## Daimler Coaches North America

#### SUBJECT: SAFETY RECALL OF 2022~2024 Mercedes Benz TOURRIDER COACHES

Ref.: NHTSA recall reference #: 24V-141 Braun recall reference #: 24E-017 DCNA Bulletin # TI 86.10T24282A

### Recall Notice Service Bulletin 407587 Rev. A

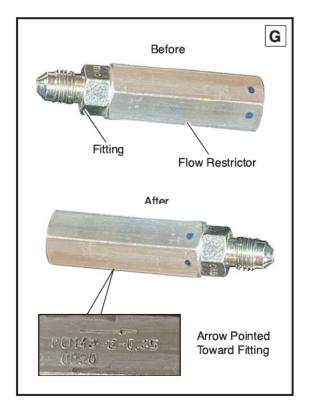
- 4. Open manual relief valve.
- 5. Remove power from lift by disconnecting the 2-pin high power connector in the carriage.

- 6. Unlock the chain release.
- Disconnect hydraulic line and flow restrictor as shown. Mark the flow restrictor with a marker. See Photos D and E.
- Disconnect flow restrictor at location indicated in Photo E and connect pressure switch to cylinder as shown in Photo F. Tighten to snug.
- Remove fitting from flow restrictor and connect to opposite end of flow restrictor. Tighten to snug. Ensure flow restrictor is oriented in the correct direction. Arrow must be pointing toward the fitting and the marks put on flow restrictor in Step 7. See Photo G.
